FCC Request for clarification - regarding FCC-ID 2AAGMVZ120Q (LTE Module; Sequans Communications);
2nd TCB answer (04-15-2016), forwarding the grantee's 1st response of 04-08-2016:

Correspondence Reference Number: 229123
Form 731 Confirmation Number: TC199652
Date of Original E-mail: 03/29/2016

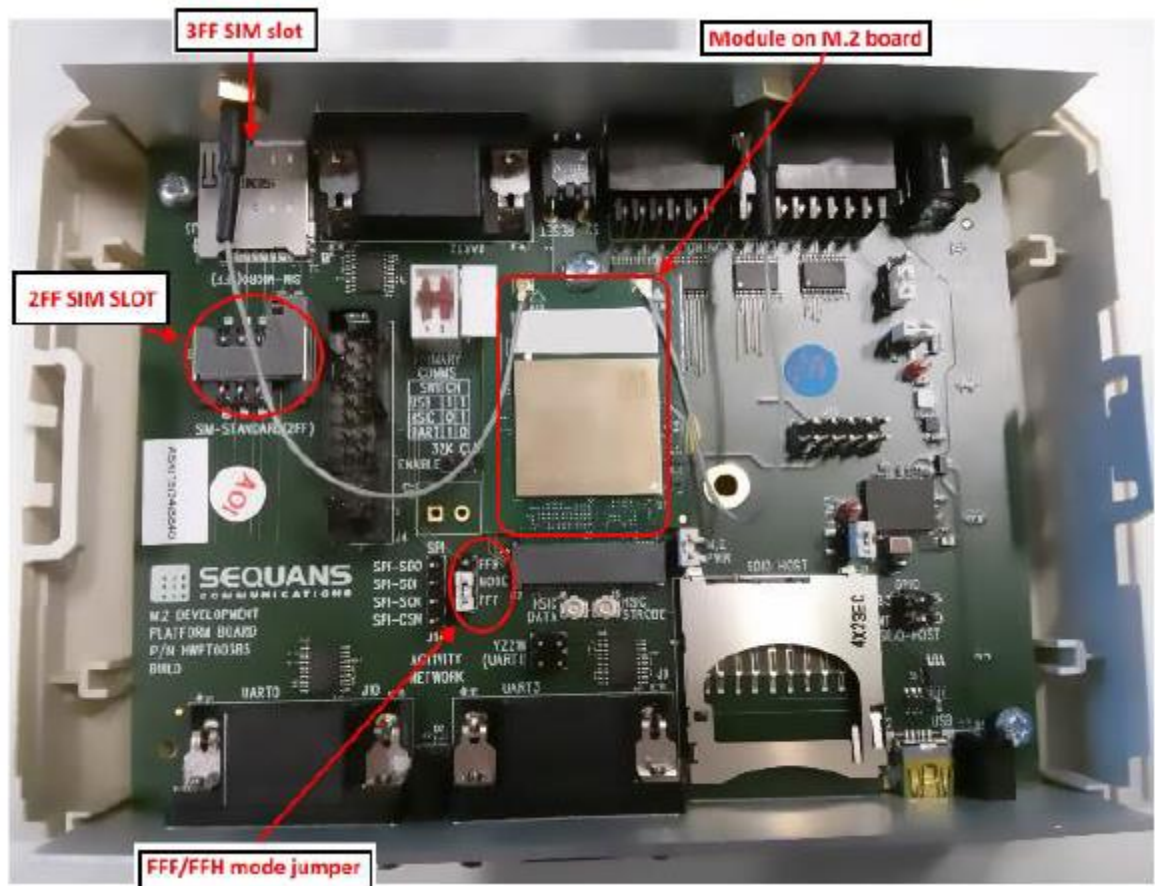
As you're pointing out, there can be confusion (and I agree on the ambiguity of the documentation and related photos) on the three items

- The shielded part [called VZ120Q module]

- The M.2 adaptation board (a.k.a. NGF) on which the VZ120Q module is soldered

- The evaluation kit in which the M.2 adaptation board is plugged

The module which is the subject of the certification is the shielded part (the VZ120Q module). The M.2 adaptation board and the evaluation kit are the vehicles used for testing the module. The M.2 adaptation board has the small antenna connectors, and a set of standardized interfaces (as per the M.2 standard). The evaluation board allows plugging external antennas through SMA connectors, and adding a SIM card, for testing sake.
